COURTYARD ROOF — GARDEN EDGE

FOR CLIENT CONFIRMATION — shape only; full set follows once confirmed

DRAWING TITLE	
GARDEN EDGE — corrected shape section, key plan & 3D	
SCALE @ A3 1:25 / 1:75	DATE 07.10.2026
DRAWN / CHECKED CC / —	SERIES ARCHITECTURAL
DRAWING No.	REV

C10-01 C10

1 SECTION ACROSS AT C1 — 1:25

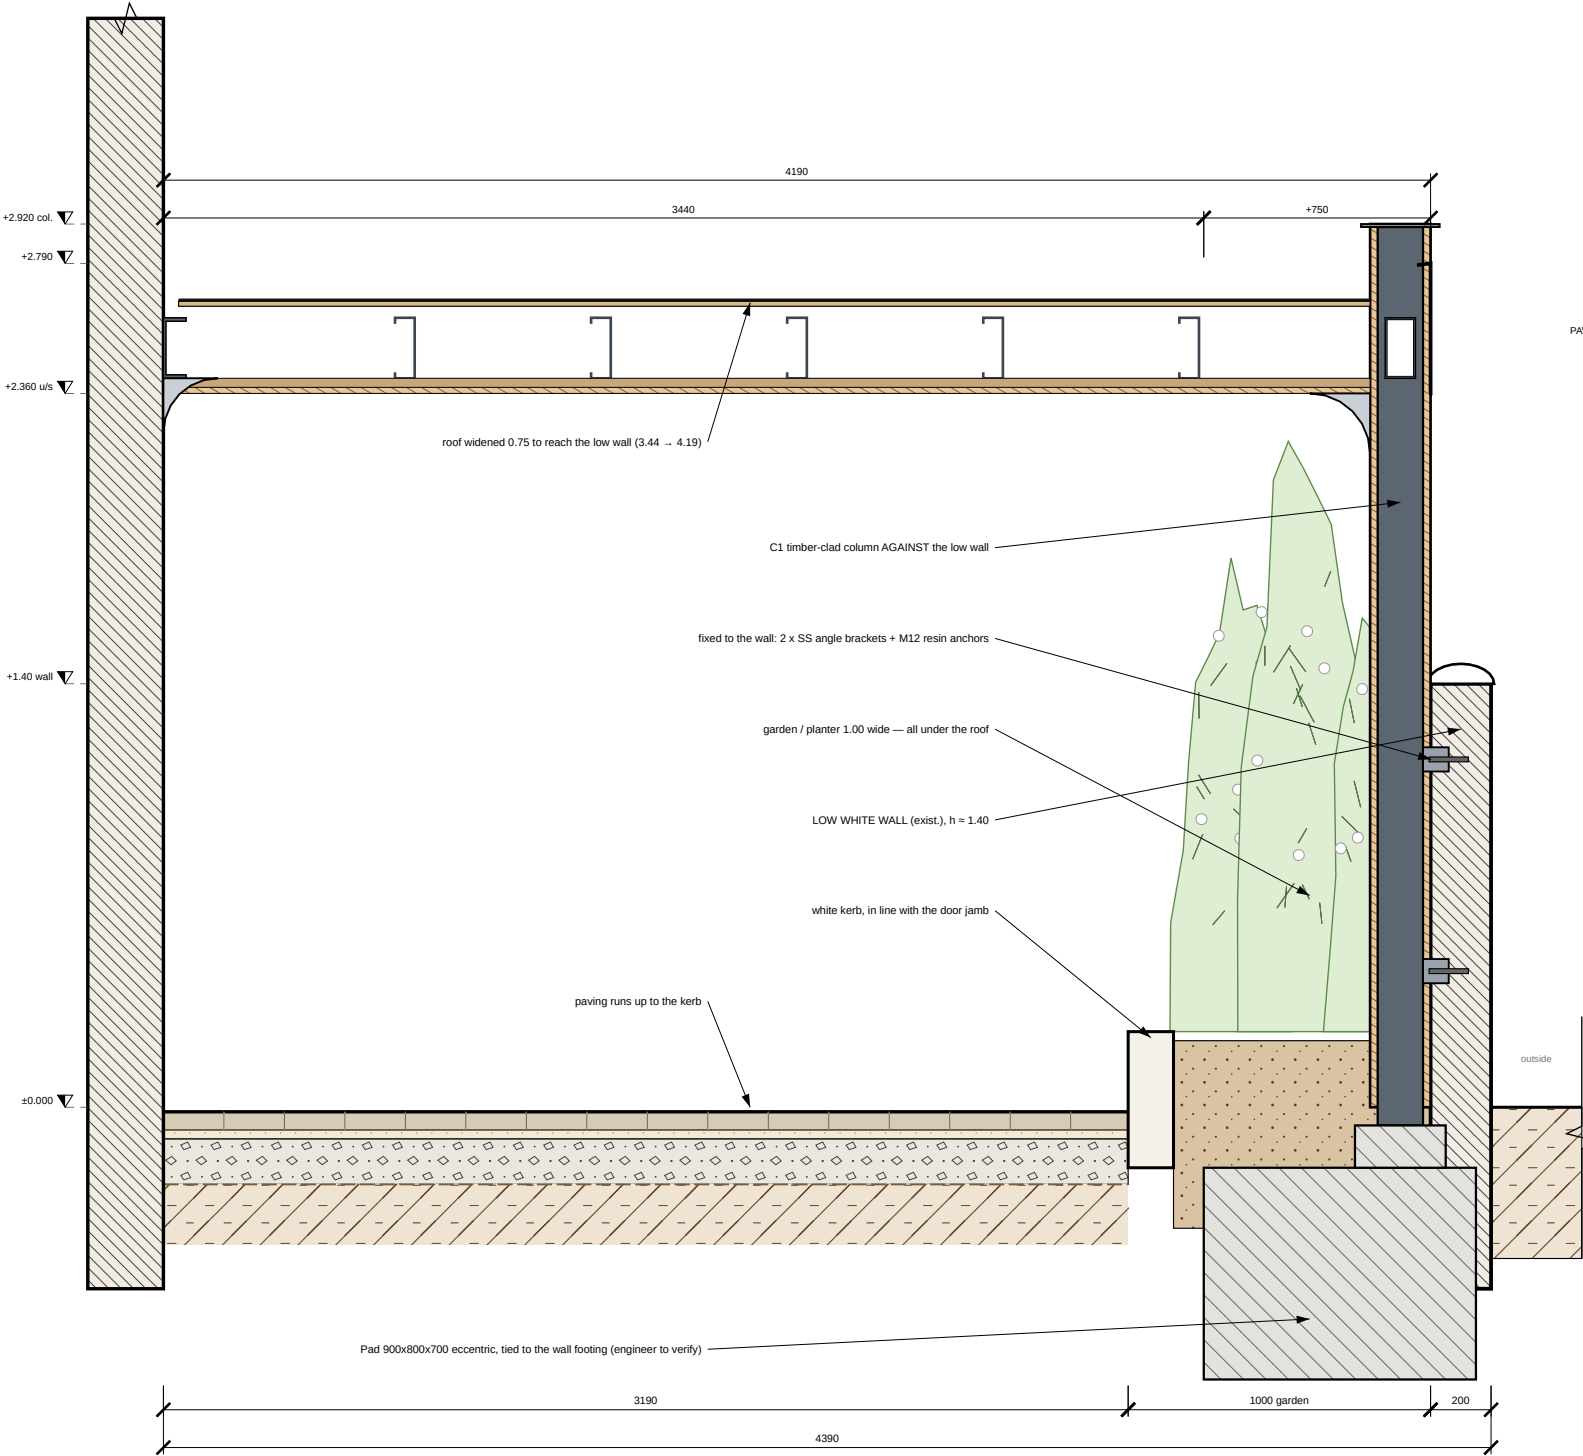
WHAT CHANGED
NEW (C10): paved entry space 1.00 m (was 0.60) between the façade and the planter's near-end kerb, so you can walk in to the left (glass) doorway next to the brown slider — as the photo. The garden CONTINUES along the low wall (no end).
Garden / planter is double: 1.00 m from the kerb (door-jamb line) to the low white wall.
The timber-clad columns stand against the low wall and are fixed to it (2 SS brackets each).
So the roof edge comes out to the wall: +0.75 m (V1 3.44 → 4.19, V2 2.54 → 3.29); the whole planter is under the roof.
PLEASE CONFIRM
Garden 1.00 + columns at the wall + roof to the wall: confirmed by you (C08). All 12 sheets follow.
